# Proposal on possible applying additional dots of glue for excluding possible damages of assembled M-FPC with PCB

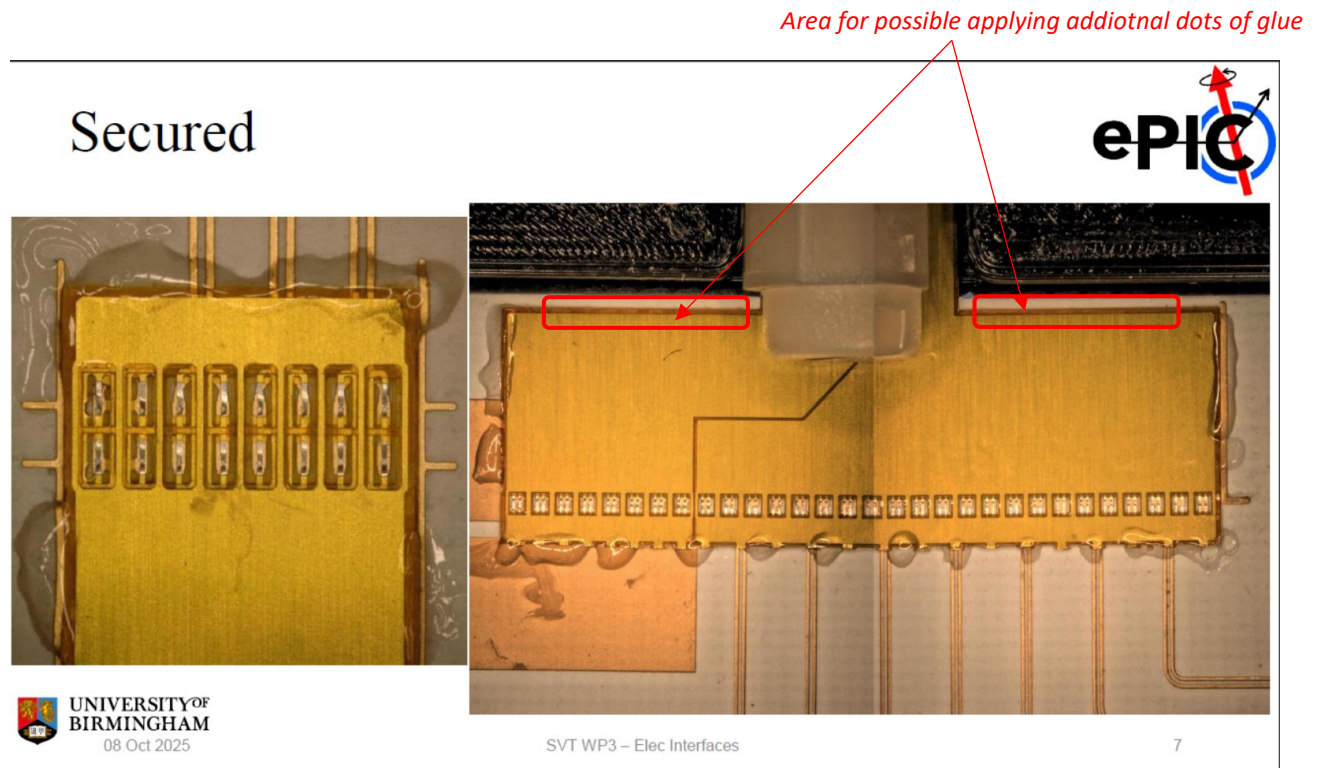
## Option 1

## Option 2
